**ONONDAGA LAKE CAPPING, DREDGING,
HABITAT AND PROFUNDAL ZONE (SMU 8)
FINAL DESIGN**

**ONONDAGA CREEK NAVIGATIONAL CHANNEL
DESIGN ADDENDUM**

AUGUST 2014

SUMMARY OF DESIGN REVISIONS

D-9

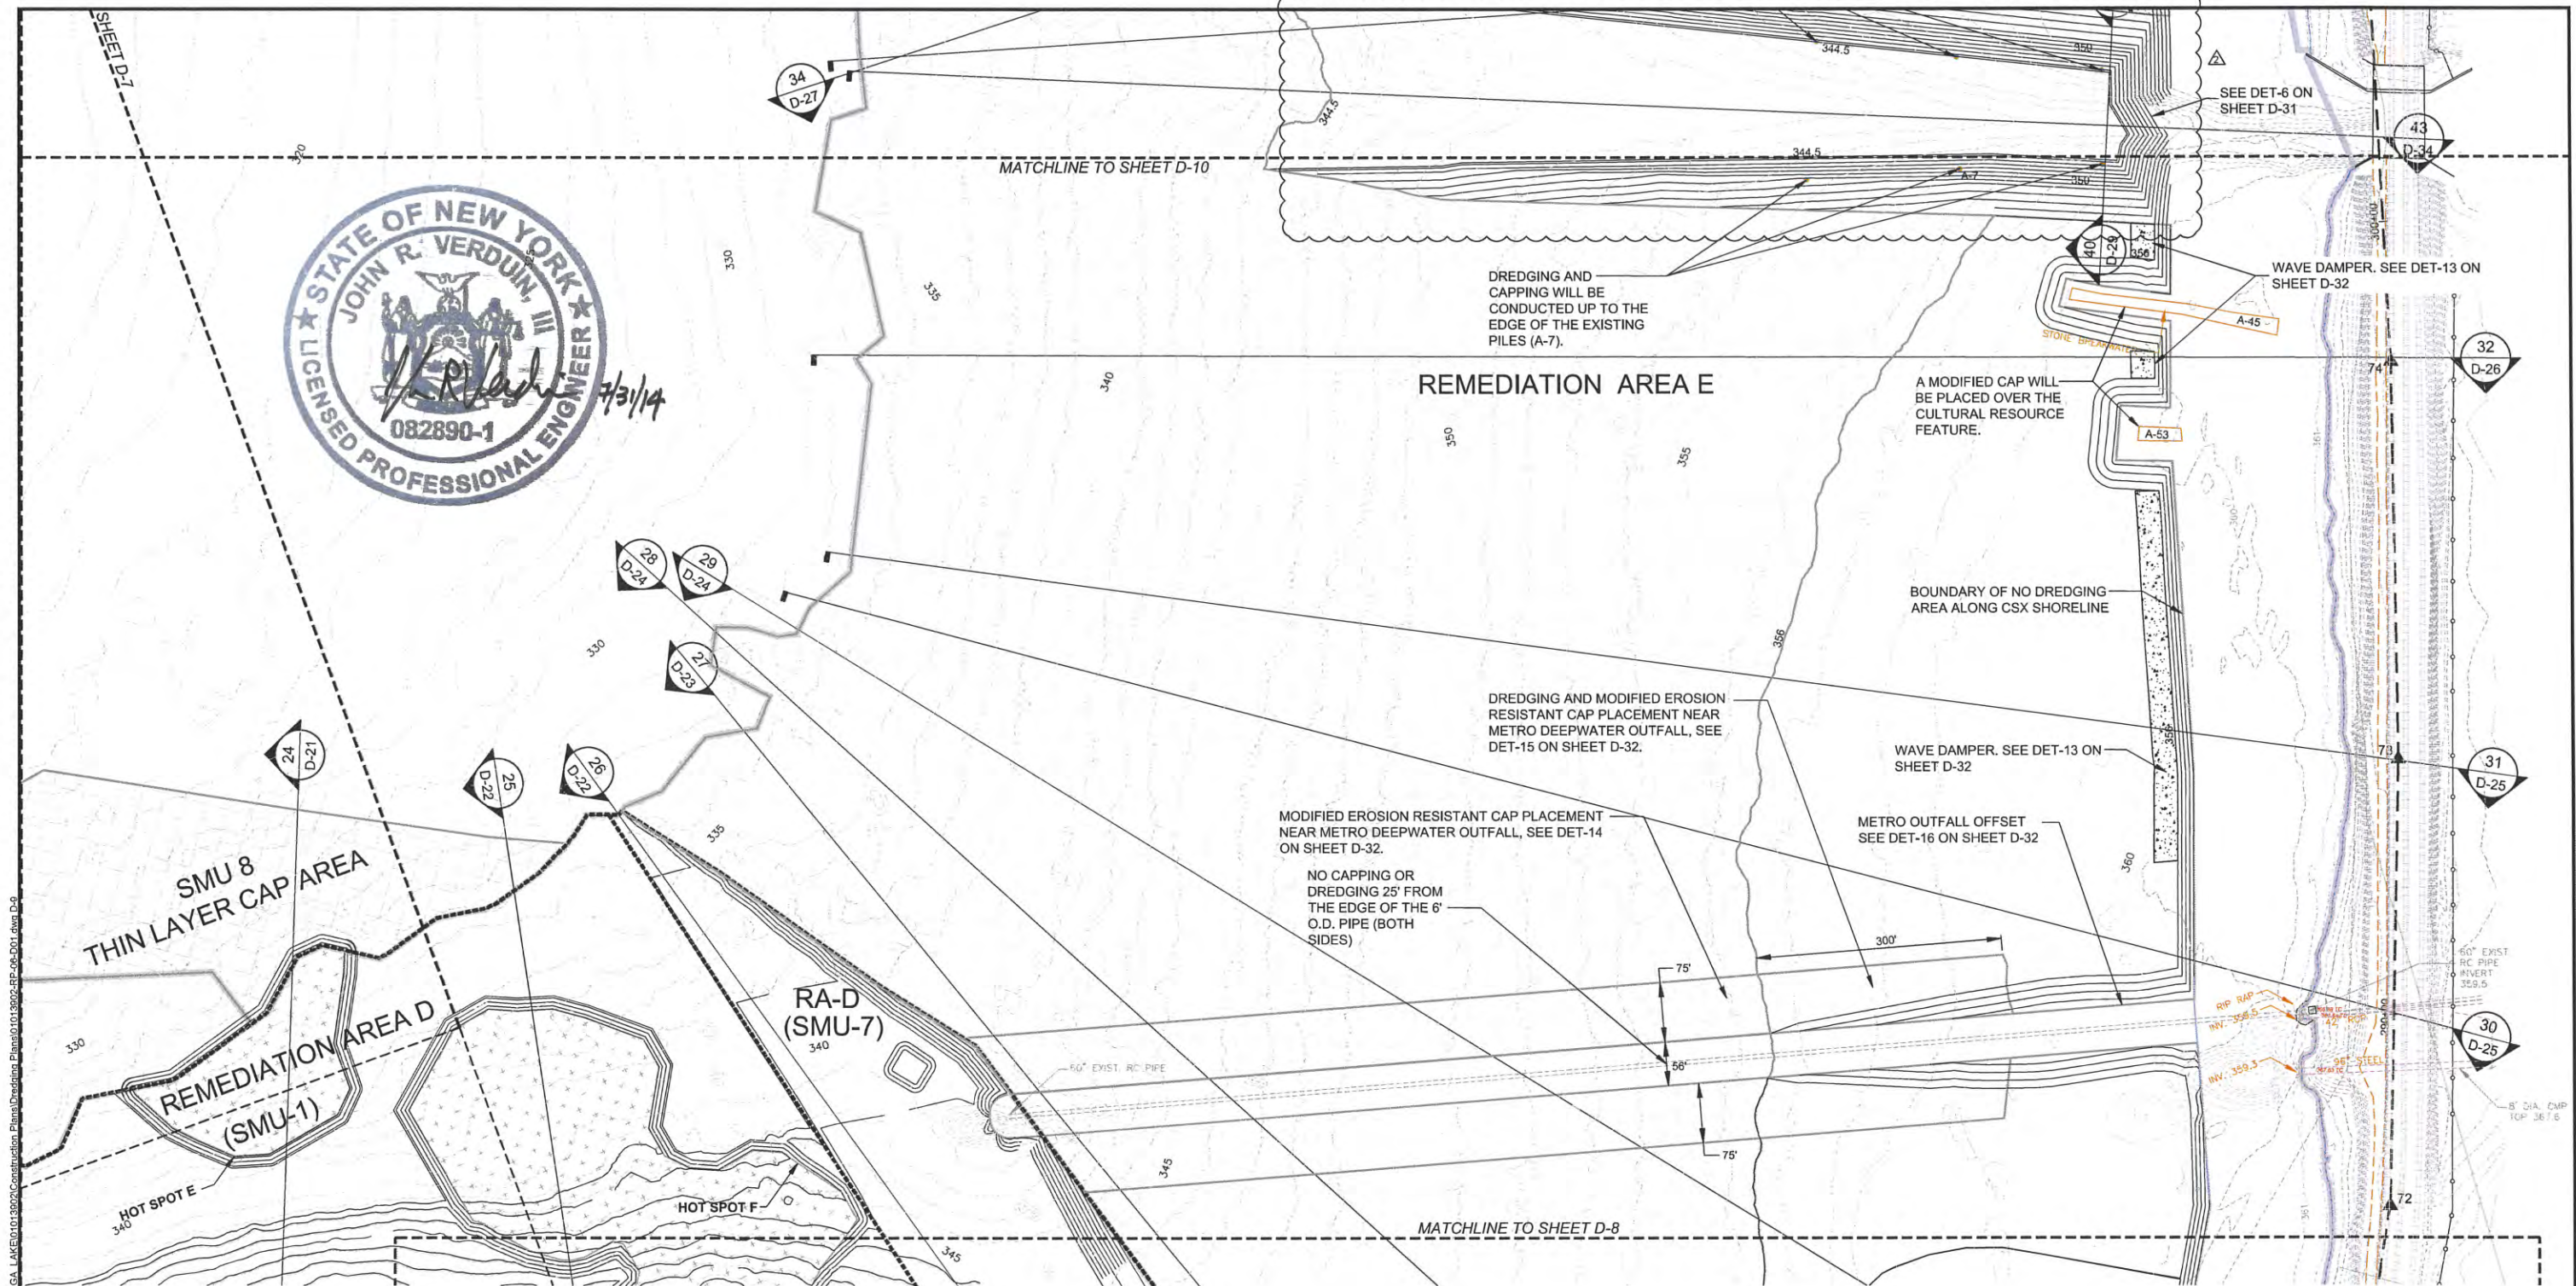
This addendum provides design revisions associated with the dredge prism within the Remediation Area E (RA-E) navigational channel leading to Onondaga Creek. The channel depth leading to Onondaga Creek must be sufficient to accommodate commercial boat traffic that uses Onondaga Creek and the Inner Harbor. Therefore, the proposed approach in the Final Design for this area was to dredge to a sufficient depth to allow cap placement while maintaining minimum required navigational depths as provided by the New York State Canal Corporation (NYSCC). Subsequent to the Final Design, the NYSCC requested that the post-capping bathymetry be consistent with the original 1915 canal design, for which they provided design drawings. The original channel was wider and slightly shallower than the channel included in the Final Design. Therefore, the design has been modified to comply with this request. Consistent with the Final Design, the revised design includes dredging to a sufficient depth such that the final cap surface is 2 feet below the navigational depth to prevent dredge-induced damage to the cap during future navigational dredging. The revised plan is presented in the attached revised design sheet.

Three active rail lines are located immediately adjacent to the shoreline in the area of the navigational channel. Geotechnical analysis indicates that dredging adjacent to the shoreline in this area, including the navigational channel within this area, could result in an unacceptable factor of safety for the shoreline and rail line stability, which could result in movement of the rail lines. Therefore, no dredging or capping is included in this area within the navigational channel. The detailed evaluation documenting the basis for this offset is provided in the Technical Support Document for the Explanation of Significant Differences for this area.

This addendum also addresses the six sets of pilings in the lake marking the entrance into the Syracuse Inner Harbor (Cultural Resource Feature A-7) and the set of pilings approximately 700 feet north of the navigational channel (Cultural Resource Feature A-72). These pilings will be left in place and capping and dredging will be conducted up to the pilings.

REVISIONS				
REV	DATE	BY	APPD	DESCRIPTION
0	03/05/12	WJD	JRV	ISSUED FOR CONSTRUCTION
1	08/07/13	WJD	JRV	ADDED CULTURAL RESOURCE A13 AND 25-FT NO CAP BUFFER
2	06/08/14	WJD	JRV	REVISED REMEDIATION AREA E

D-10

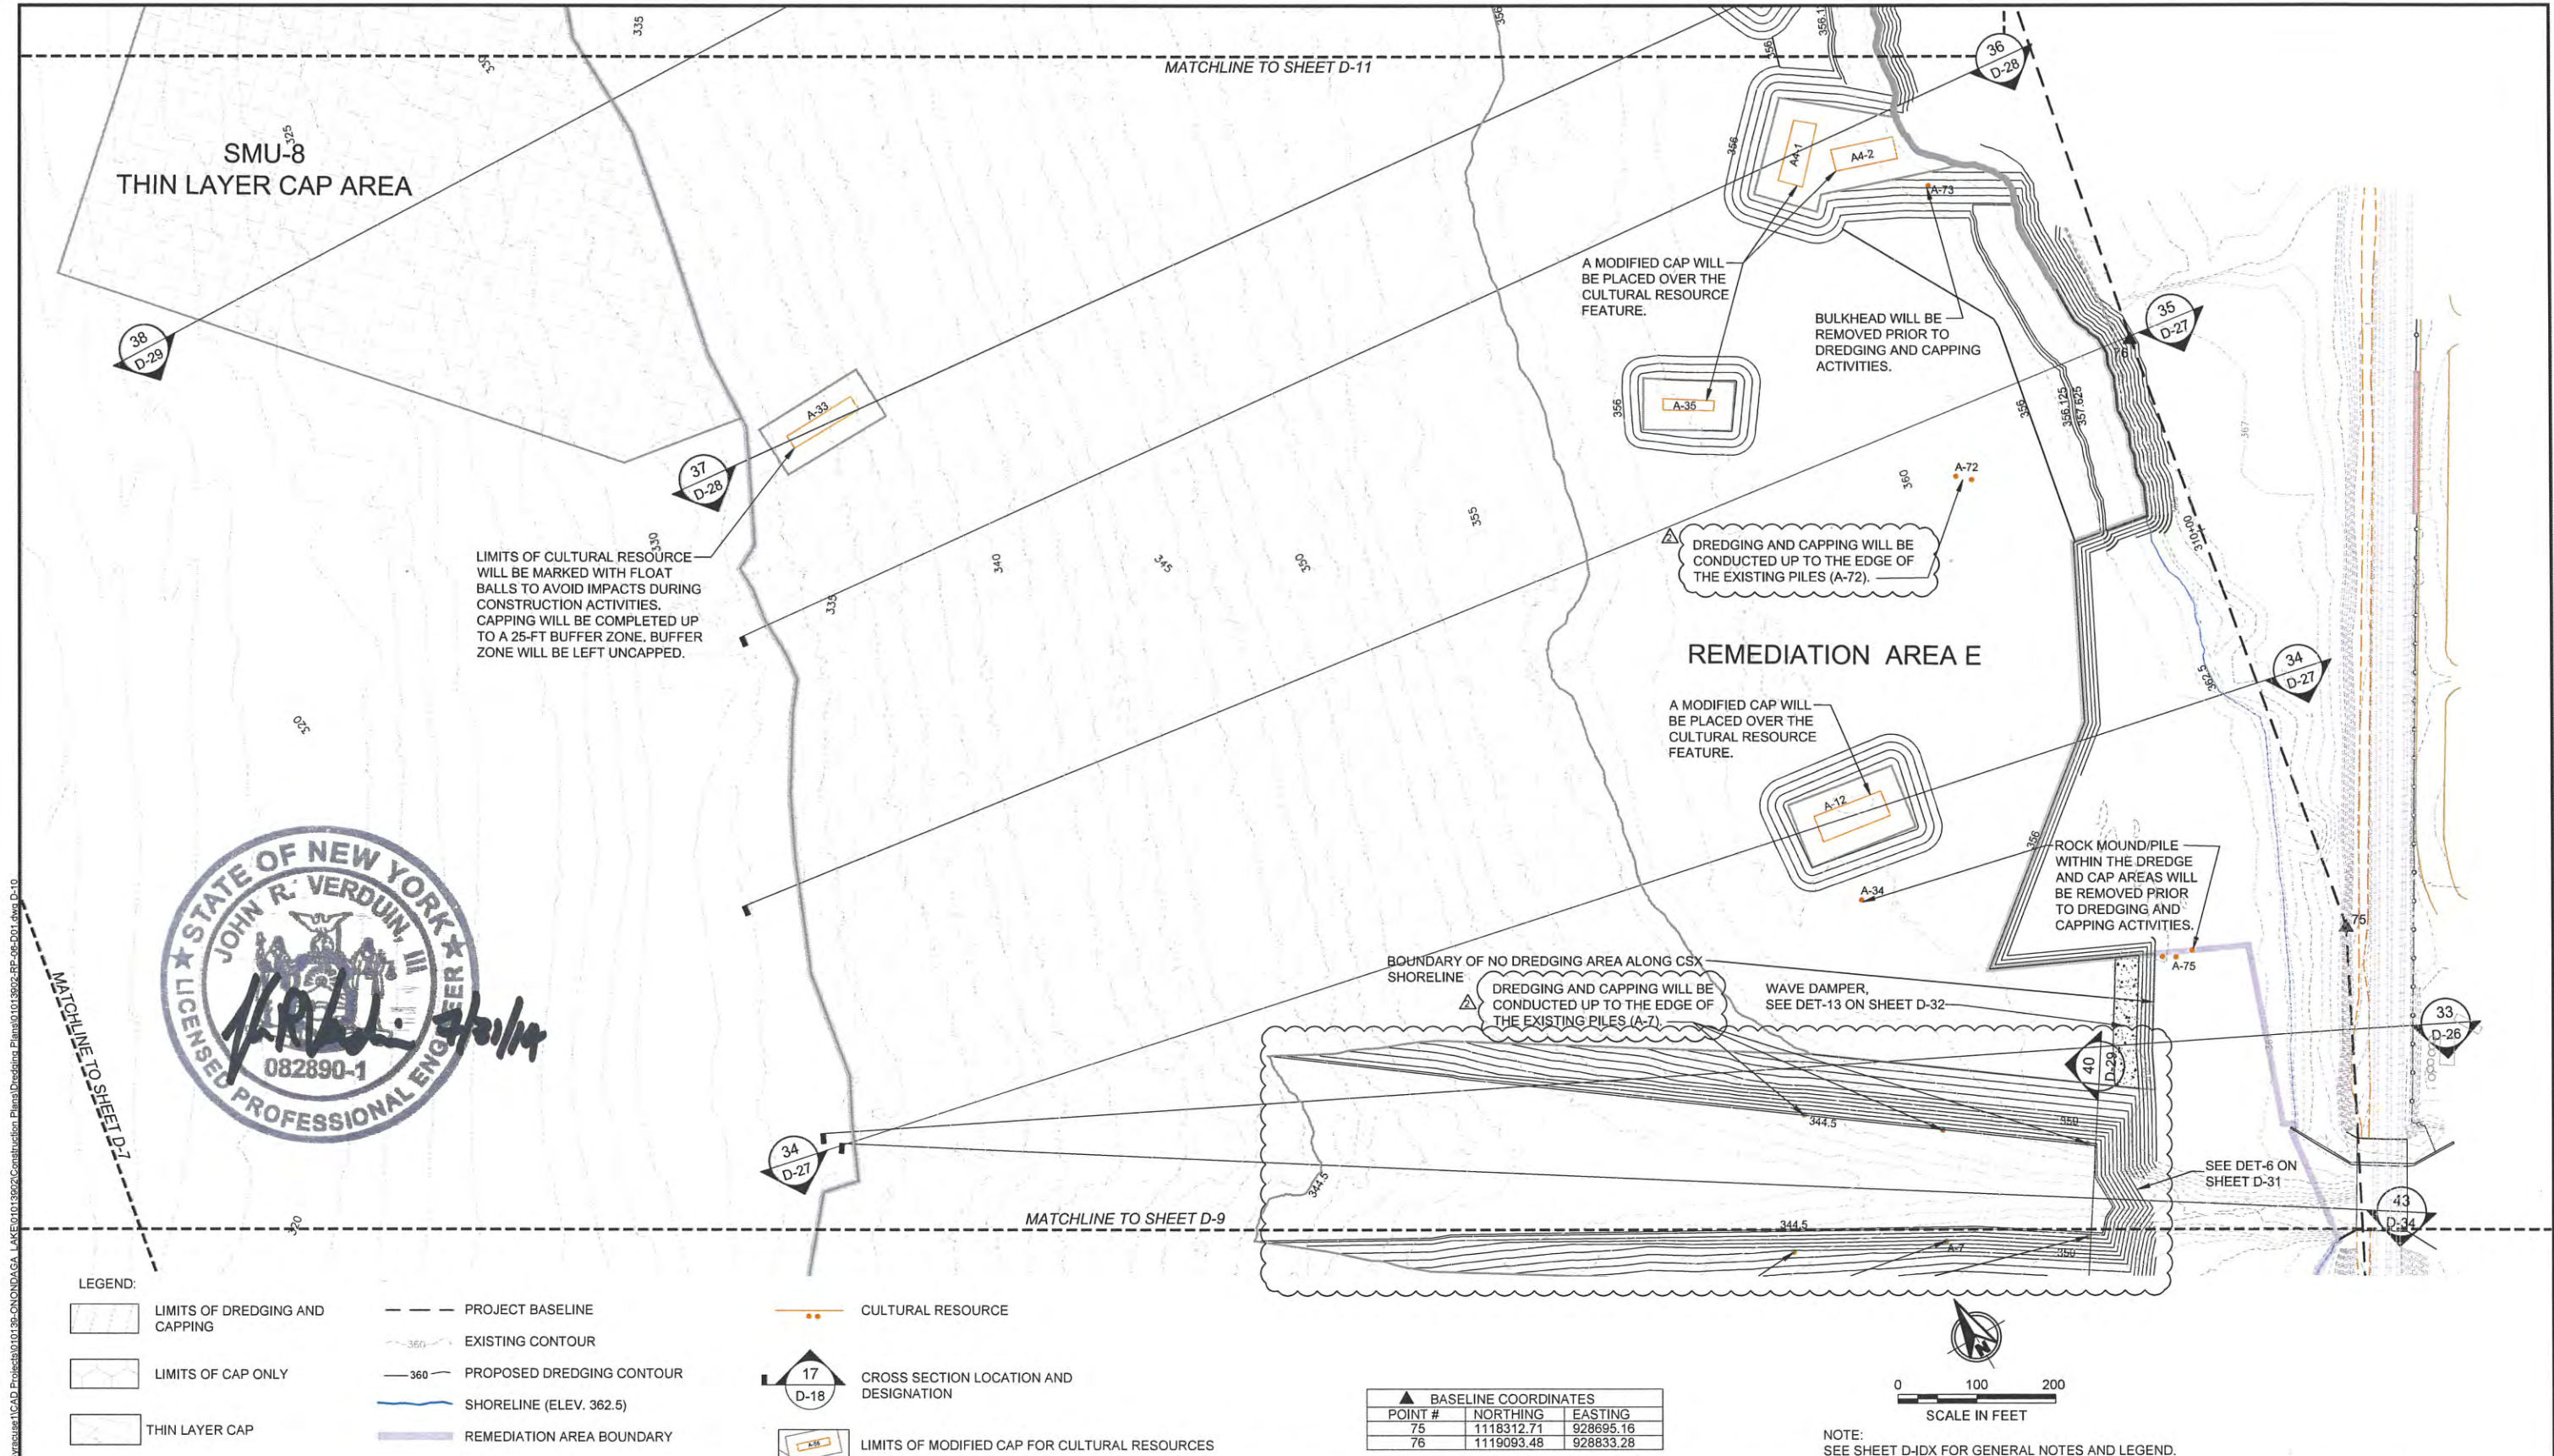
REVISIONS				
REV	DATE	BY	APPD	DESCRIPTION
0	03/05/12	WJD	JRV	ISSUED FOR CONSTRUCTION
1	08/07/13	WJD	JRV	ADDED CULTURAL RESOURCE A13 AND 25-FT NO CAP BUFFER
2	08/08/14	WJD	JRV	REVISED REMEDIATION AREA E

D-29

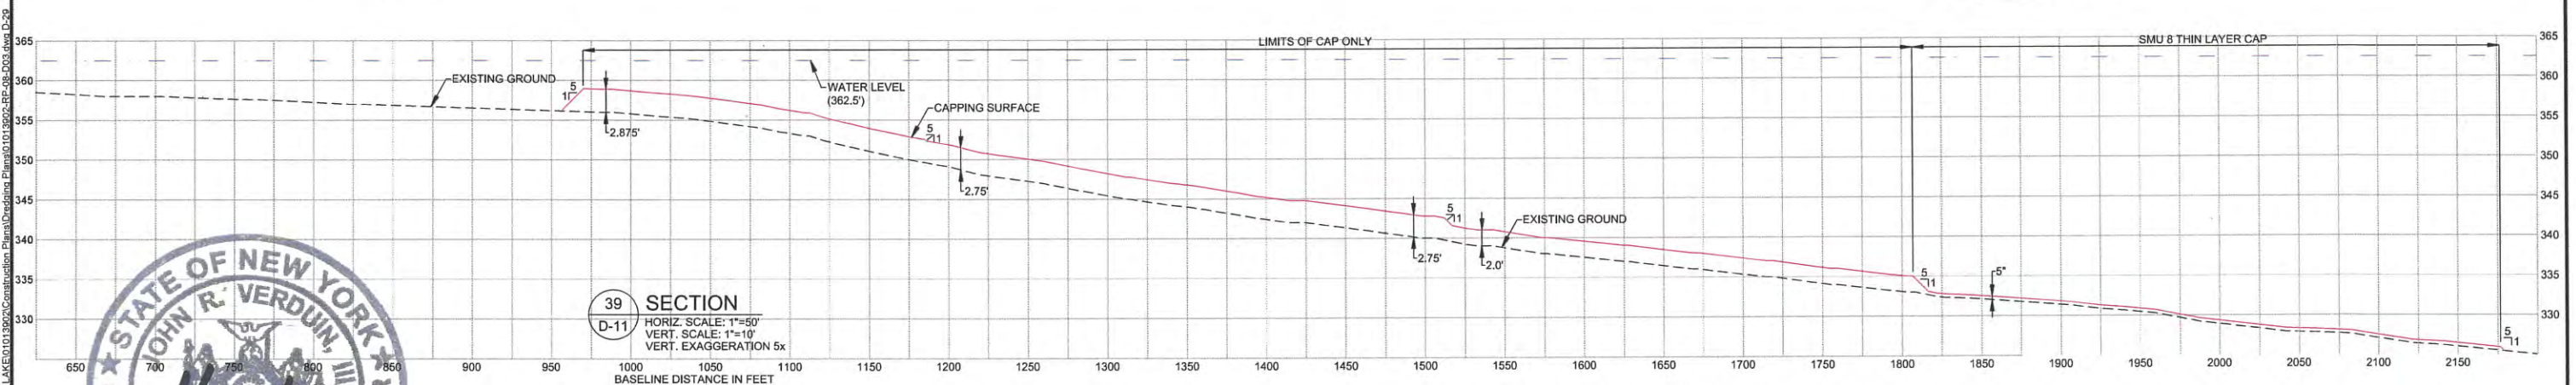
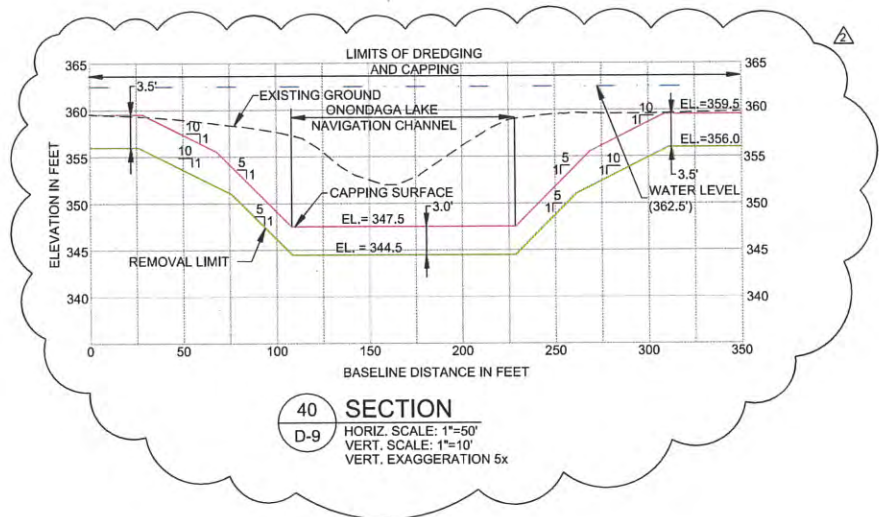
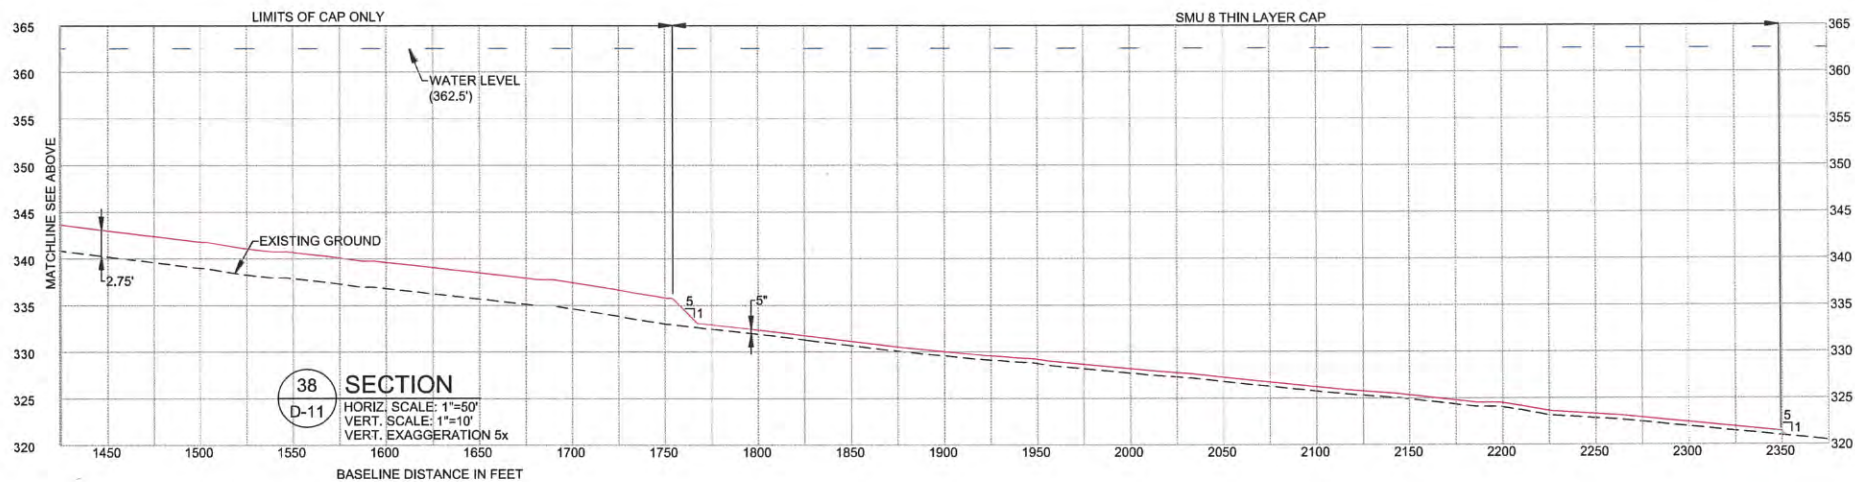
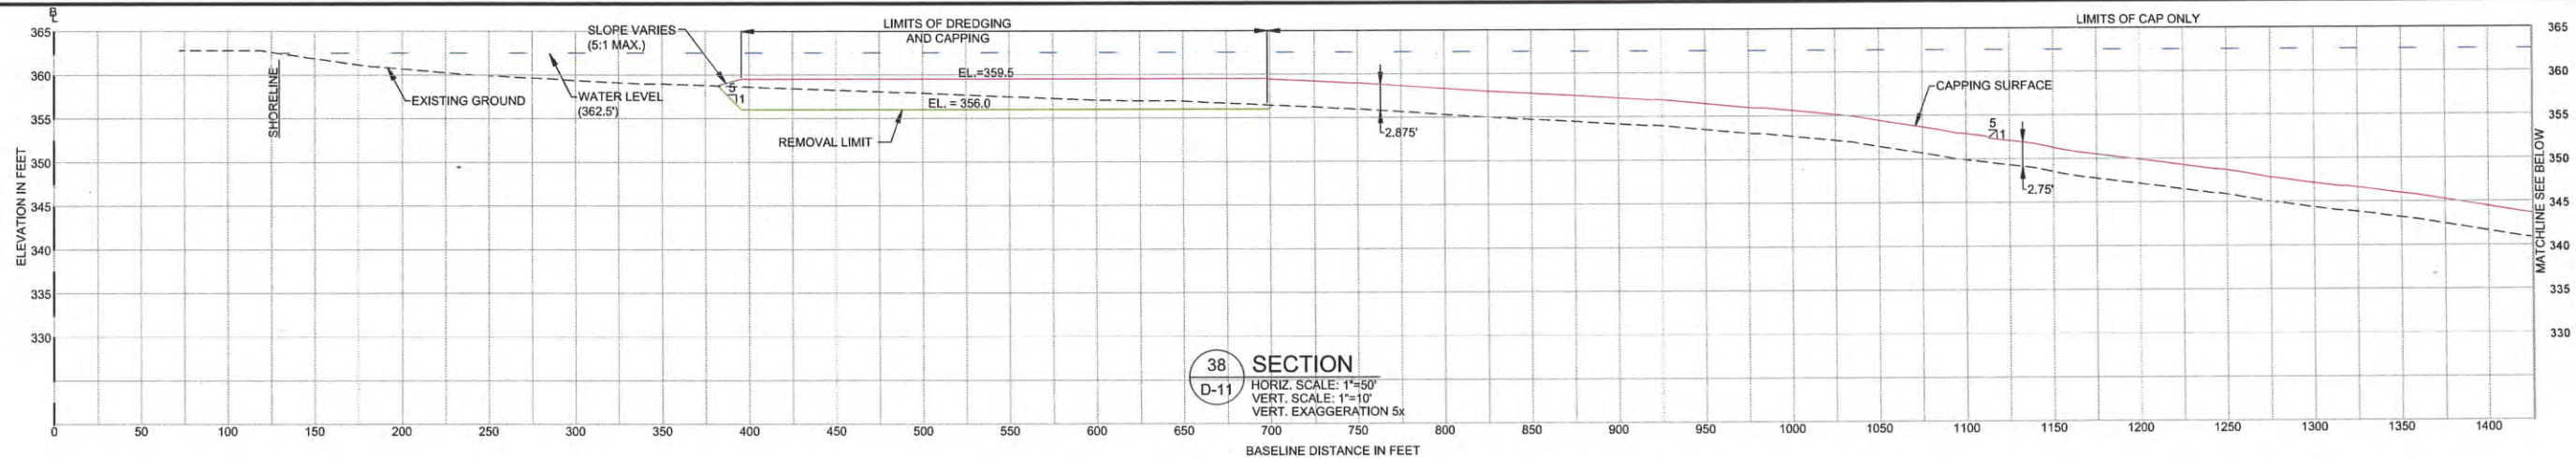
REVISIONS					
REV	DATE	BY	APP'D	DESCRIPTION	
0	03/05/12	WJD	JRV	ISSUED FOR CONSTRUCTION	
1	08/07/13	WJD	JRV	ADDED CULTURAL RESOURCE A13 AND 25-FT NO CAP BUFFER	
2	06/06/14	WJD	JRV	REVISED REMEDIATION AREA E
